SUBJECT: PLANS AND PROPOSAL ADDENDUMS

PROJECT: C 910-8-80

**GUS ENGELING WMA  
 SUPPLEMENTAL  
 INDEX OF SHEETS**

GUS ENGELING WMA  
TYPICAL SECTIONS

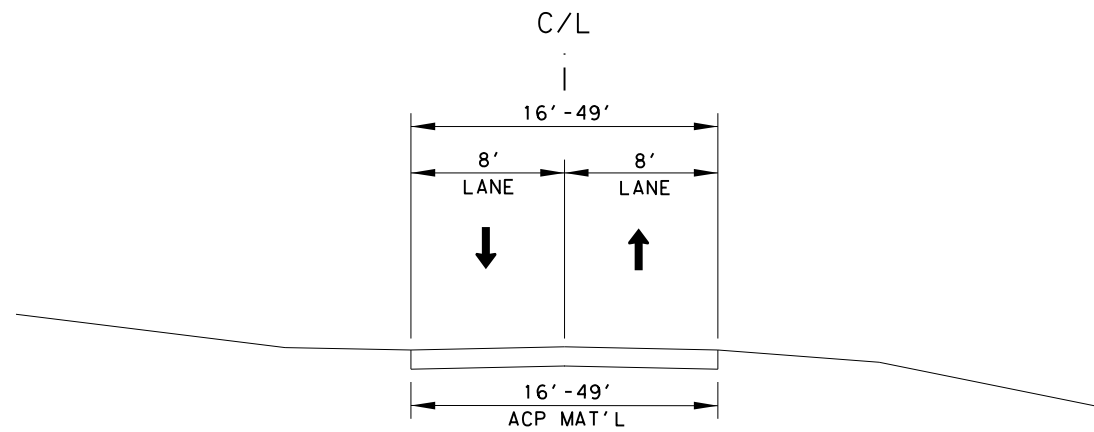
PLAN SHEET 2

-----  
ADDED SHEET 4A

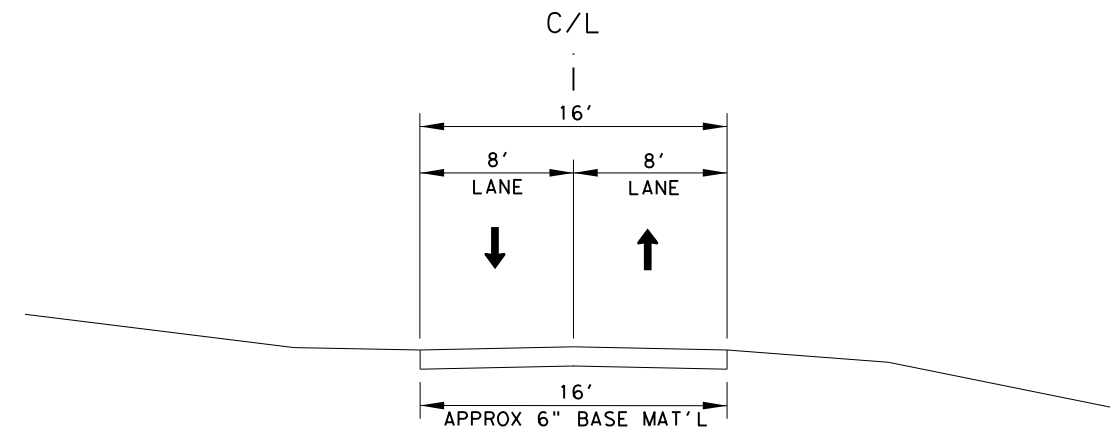
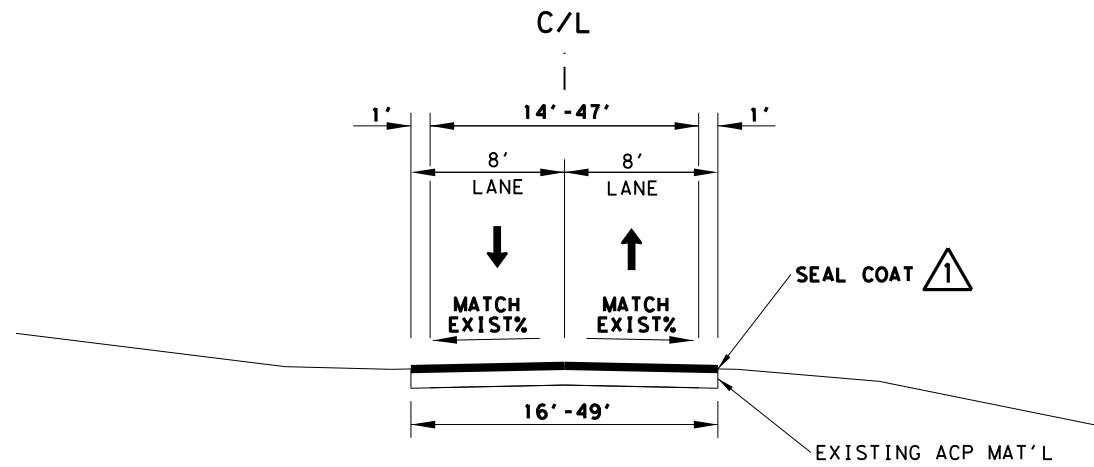
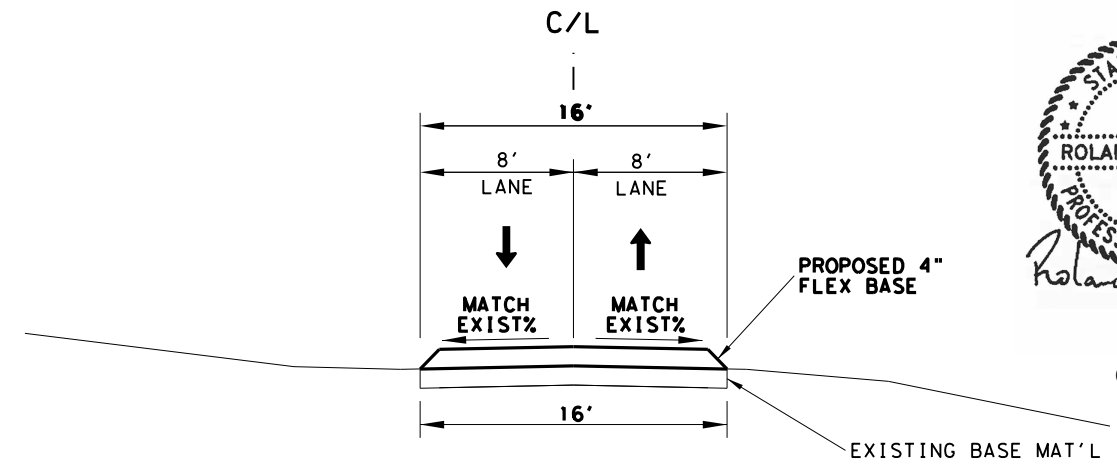
PLAN SHEET 3

-----  
REVISED TYPICAL SECTION

TYPICAL SECTIONS

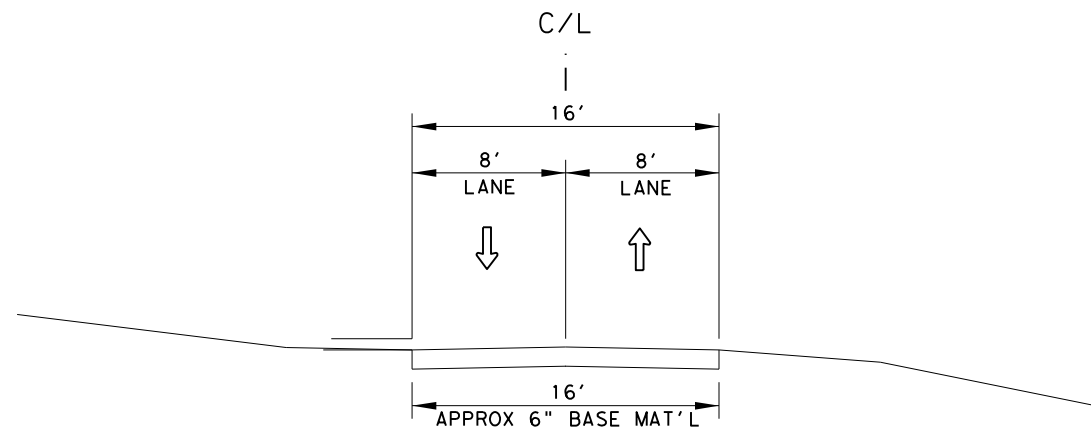
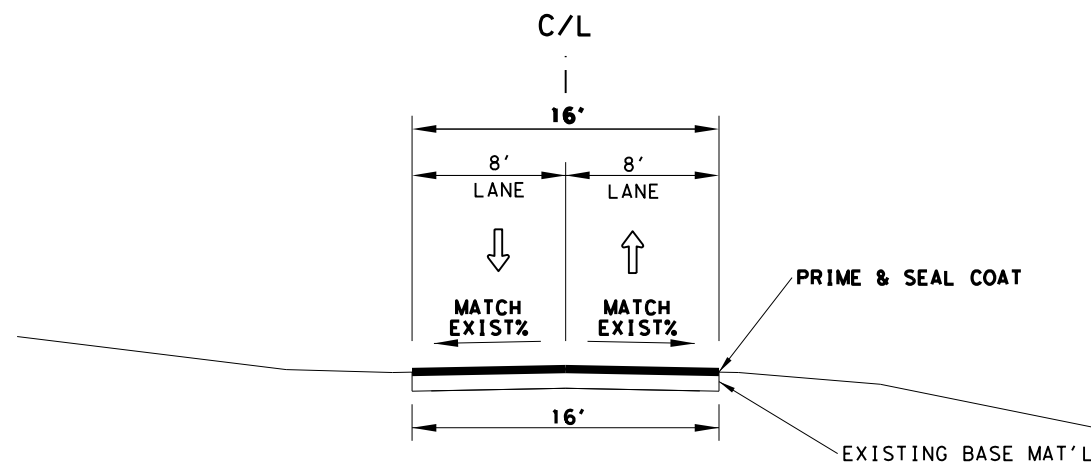
PLAN SHEET 4A

-----  
ADDED TYPICAL SECTION

**GUS ENGELING WMA  
 PARK ROAD  
 PLAN LAYOUT**

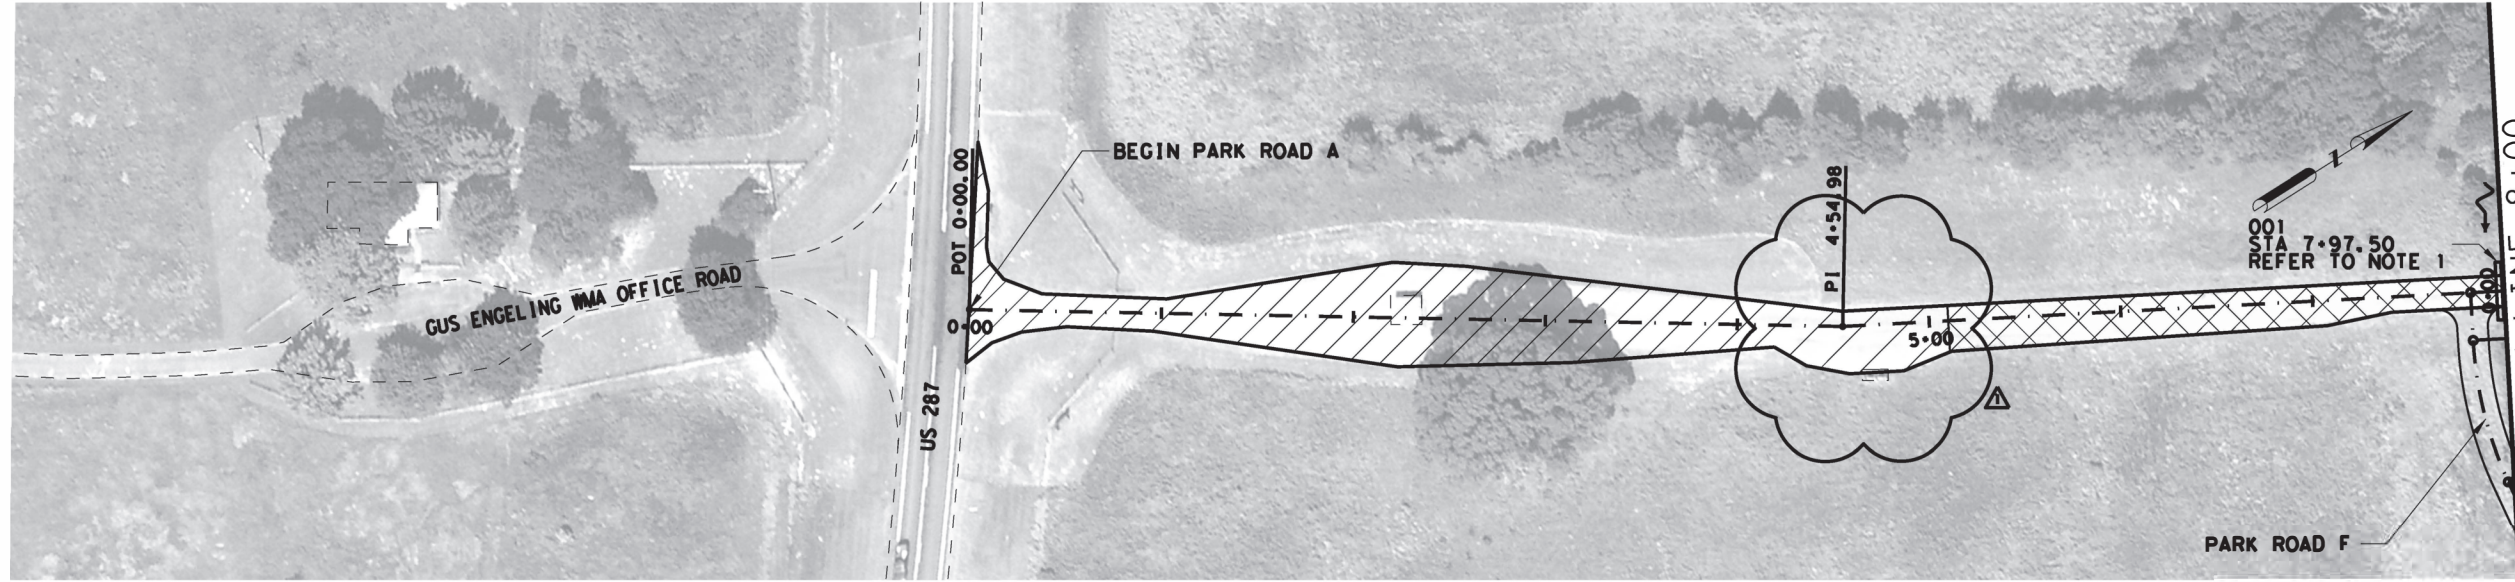
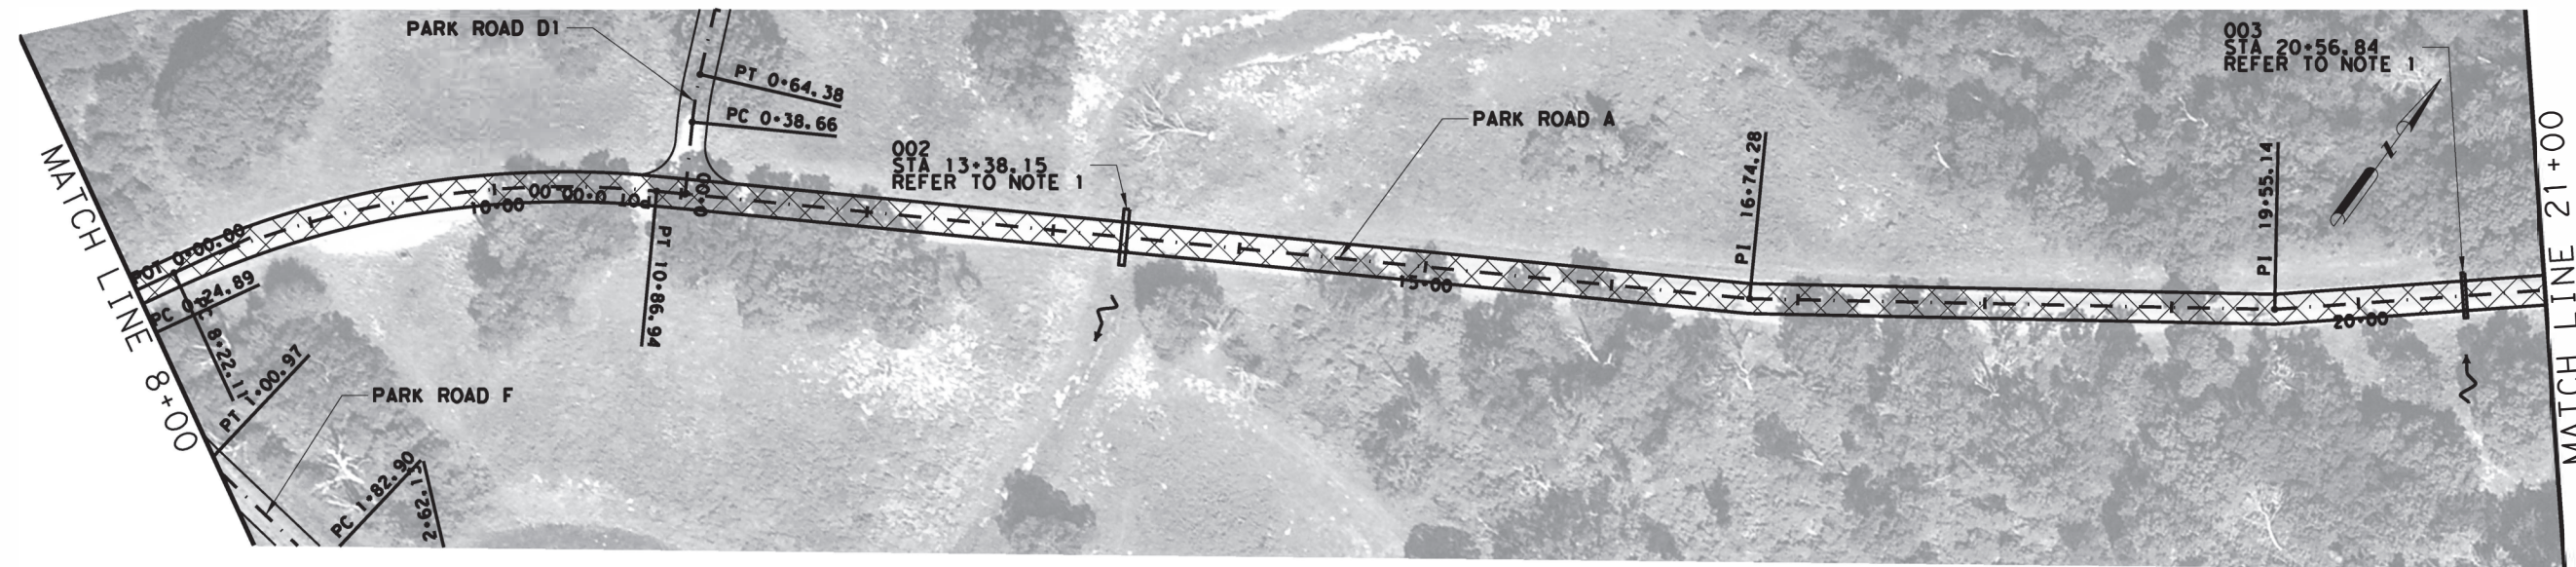
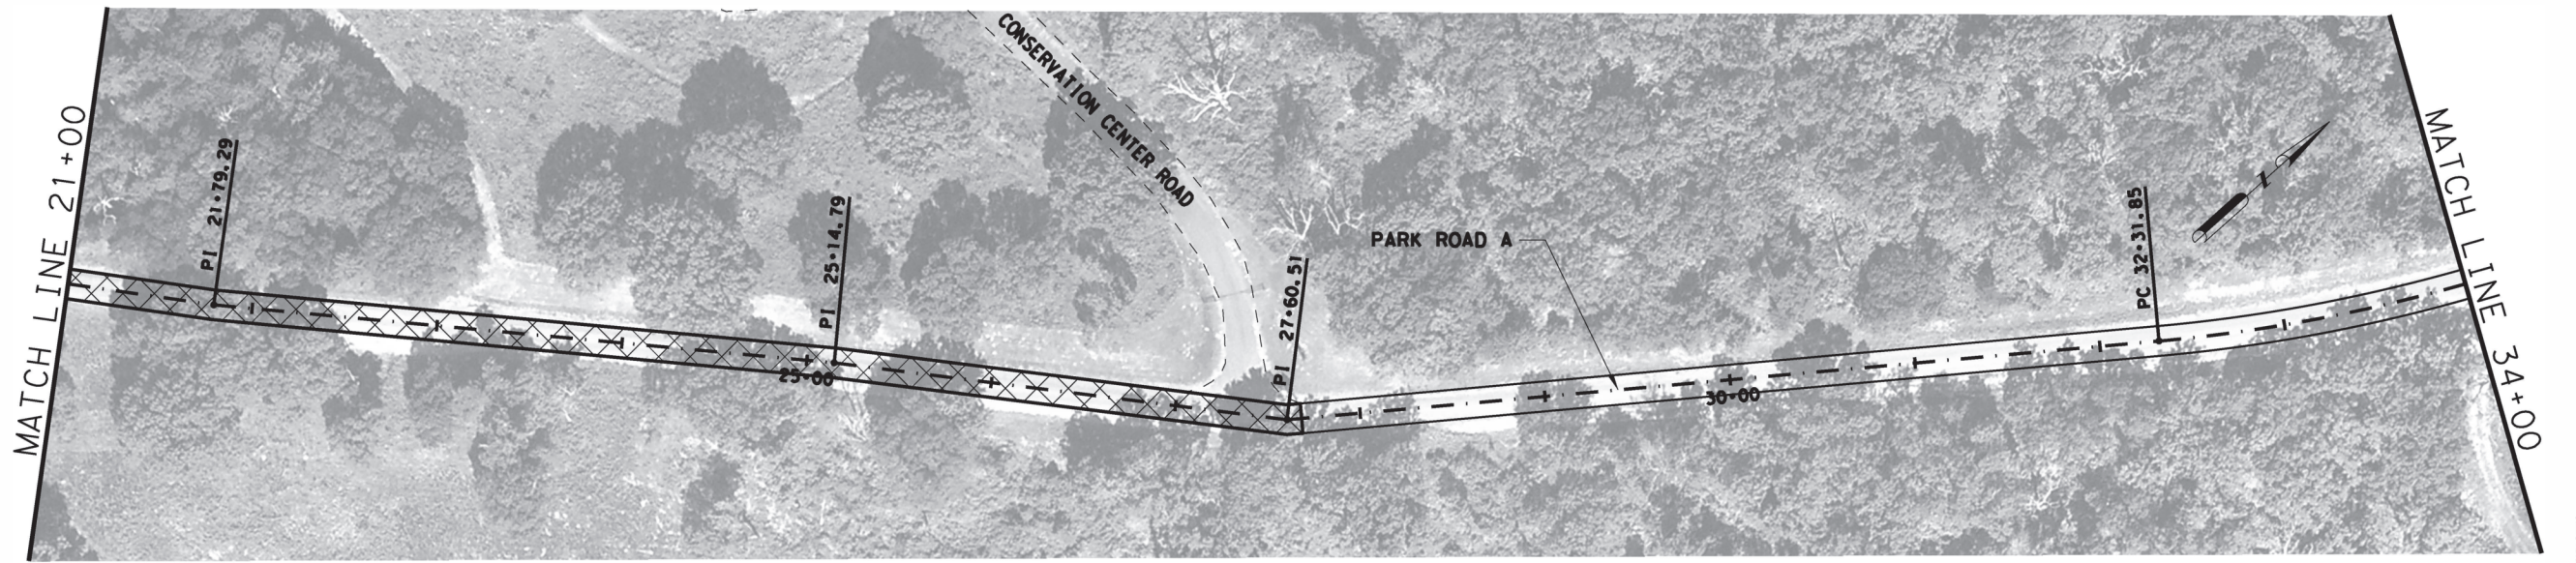
PLAN SHEET 29

-----  
REVISED PLAN LAYOUT
